SOUTH HOLLAND DISTRICT COUNCIL

Reference: H18/0694/93 Received:23-JUL-93 Type:CONDITION COMPLIANCE

Description: Additional car parking spaces (location & surfacing) and Floodlighting (Conditions 3 & 20 of application H18/0458/93)
Location : Site north of A17 Sutton Bridge
Spalding Lincs

TOWN AND COUNTRY PLANNING GENERAL DEVELOPMENT ORDER 1988
CONTROL OF DEVELOPMENT ALONGSIDE TRUNK ROADS
PROPOSED ADDITIONAL CAR PARKING SPACES (LOCATION AND SURFACING) AND FLOODLIGHTING (CONDITIONS 3 & 20 OF APPLICATION H18/0458/93) AT LAND NORTH OF A17 AND EAST OF RAILWAY LANE, SUTTON BRIDGE - A17 KINGS LYNN - NEWARK TRUNK ROAD

PLANS AND ELEVATIONS AS PROPOSED
DRWG. 228/3/10s SCALE 1:200 JULY 1993

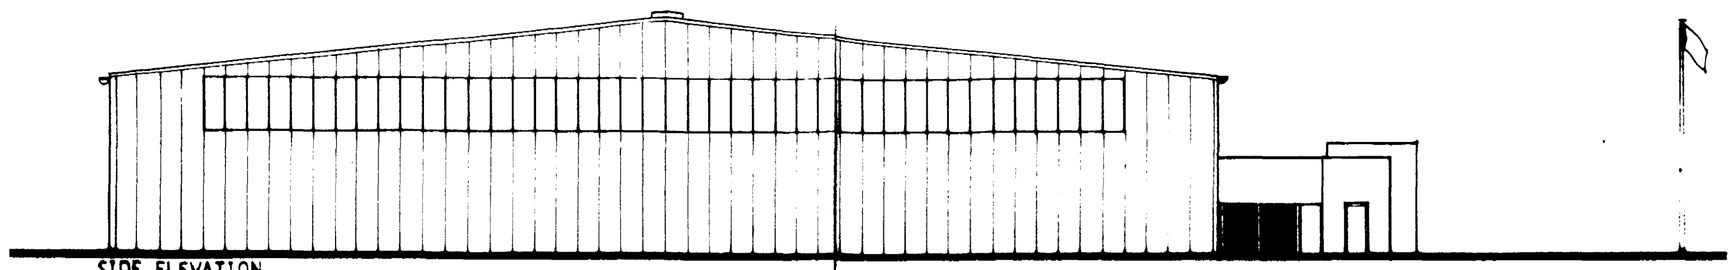
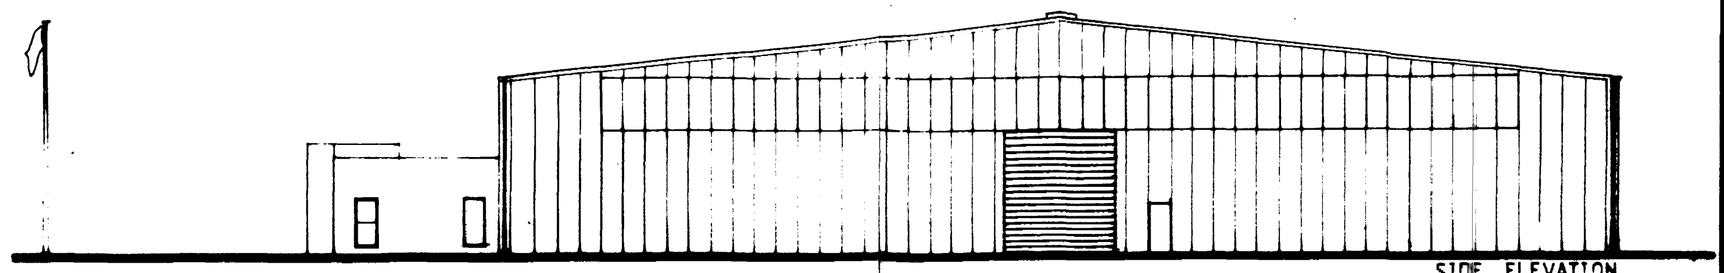
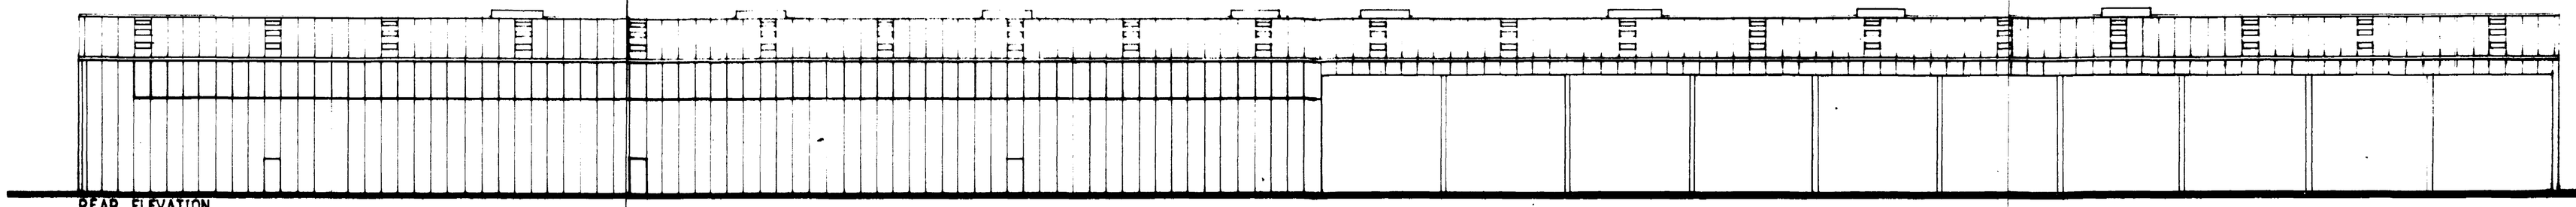
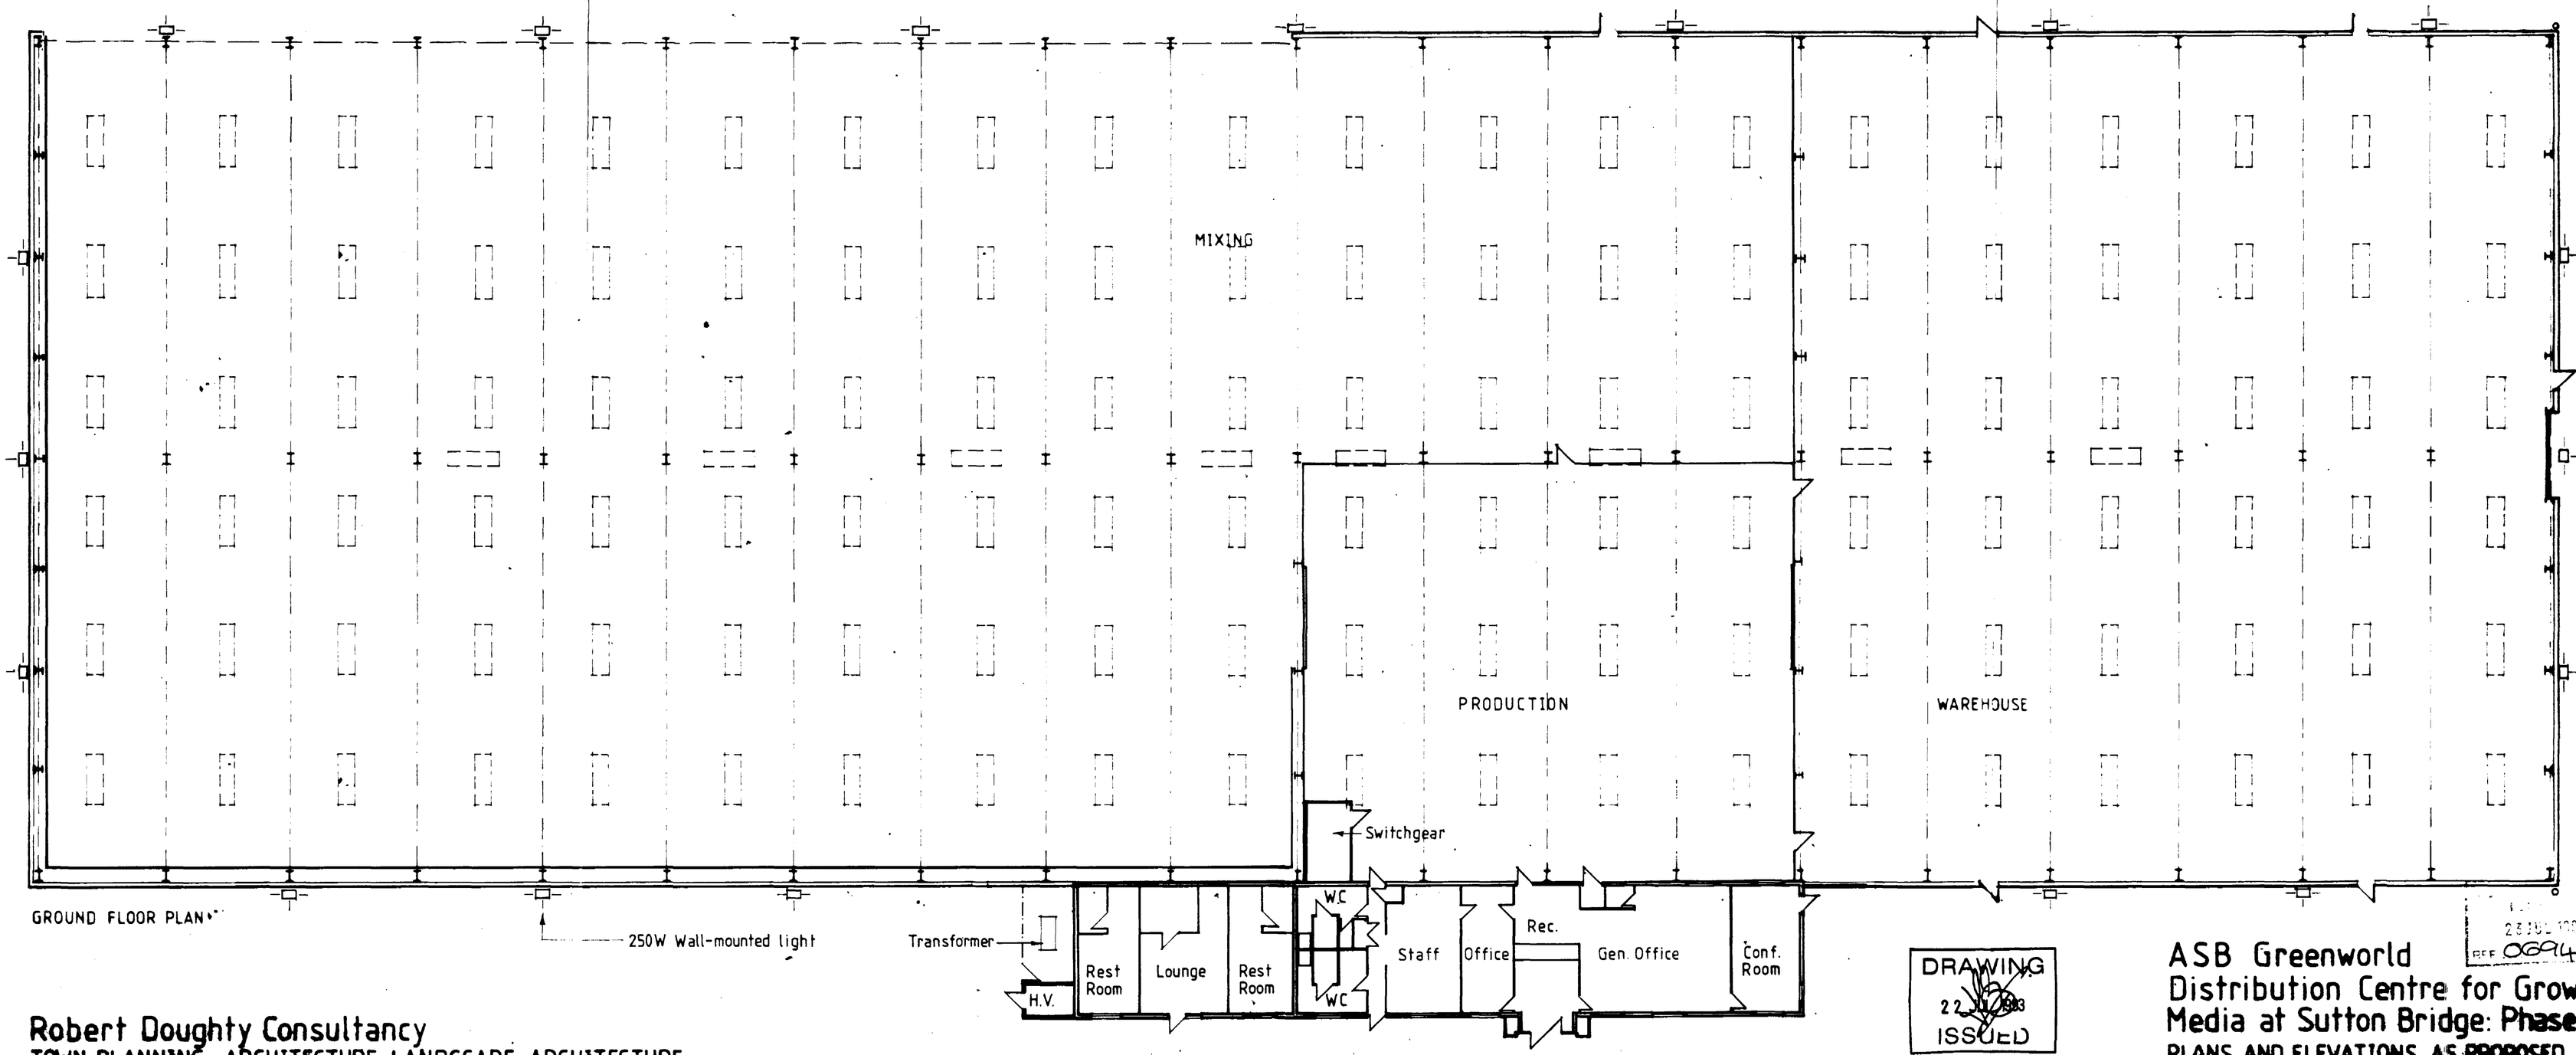
1) The applicant shall agree measures with the Department for light attenuation measures at the highway boundary of the site between the proposed earth bunding either side of the proposed portal framed building before the site is brought into use.
2) The light sources to the floodlighting on the south, east and west facades of the proposed portal framed building shall not be visible to passing drivers on the trunk road.

1) To prevent headlight glare from vehicles on the A17 trunk road by vehicles both manoeuvring on the proposed industrial estate road and car parking areas.
2) To prevent glare and unnecessary distraction from passing drivers on the A17 trunk road.

Additionally, they have urged that the light sources of the floodlighting on the southern, eastern and western facades of the proposed portal frame building are not visible to passing drivers on the trunk road, to prevent glare and unnecessary distraction suffered by the latter.
